# STAFF RECOMMENDATION

NCPC File No. 6785

**WHITE OAK FEDERAL RESEARCH CENTER  
FOOD AND DRUG ADMINISTRATION  
NORTHEAST PARKING GARAGE AND TUNNEL EXTENSION  
Montgomery County, Maryland**

Submitted by the General Services Administration

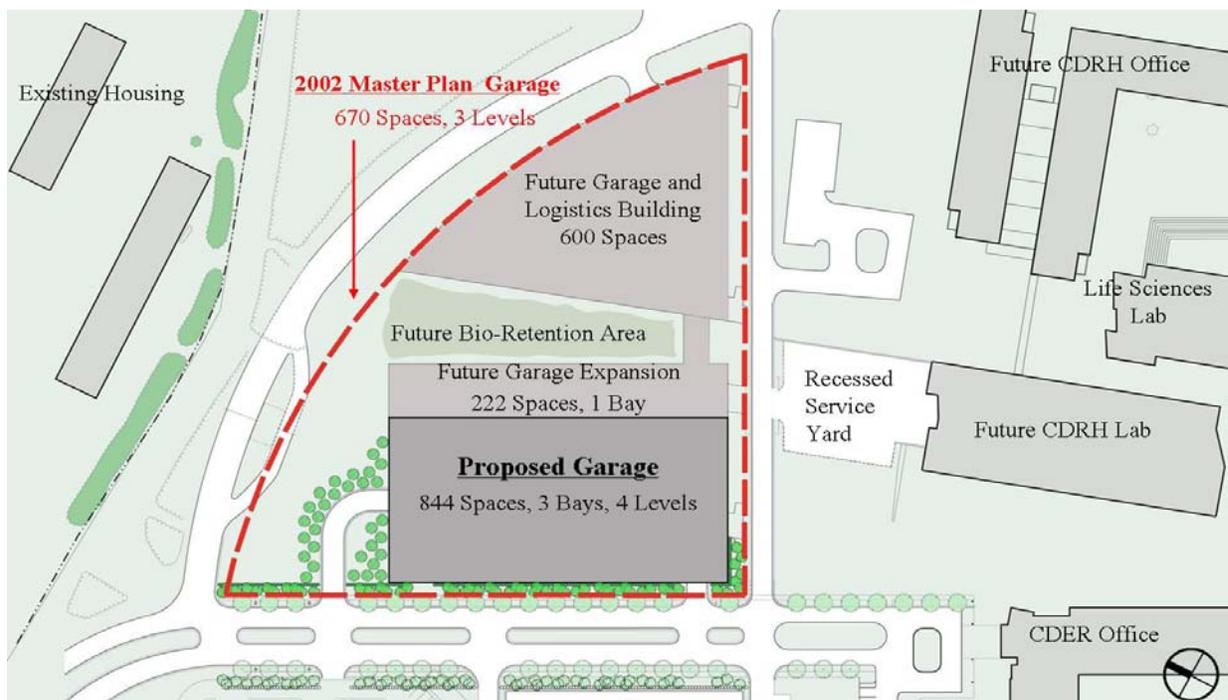
The submission includes a Phase IV Phasing Plan showing a parking ratio of 1 space for every 1.35 employees. A parking ratio of 1 space for every 1.26 employees was approved for Phase IV by the Commission on May 3, 2007. It should be noted that the overall parking and employee numbers have shifted due to the removal of the Distribution Facility and the increase of parking spaces to the Northeast Garage to this phase, and staff recommends that the parking ratios be recalculated to reflect these changes in subsequent phases.

Visitor parking was also detailed in the Commission approved Master Plan Update in June 2006 and consisted of 500 parking spaces at the completion of the entire project. These parking spaces were further designated as parking for both infrequent and frequent visitors, 282 and 218 spaces respectively. Infrequent visitors were only allowed to use the surface parking, while the frequent visitors would be pre-screened and be issued special badges allowing them access to parking garages and surface lots inside the security perimeter. In May 2007, the Commission approved the current Phase IV Plan which includes 400 visitor spaces, and includes 130 infrequent visitor spaces and 270 frequent visitor spaces. Staff recommends that when the applicant submits an update for the remaining phases of this project that these numbers reflect the current visitor parking ratios.

The Phase IV Plan included in this submission no longer includes the Distribution Facility, for which the applicant has explained that its programming is now in flux and requires additional study. The applicant stated that if the garage were not to be programmed and funded separately, the Distribution Facility programming would delay its implementation. Therefore, staff recommends that the applicant submit a modified Phasing Plan V and/or VI to include the Distribution Facility.
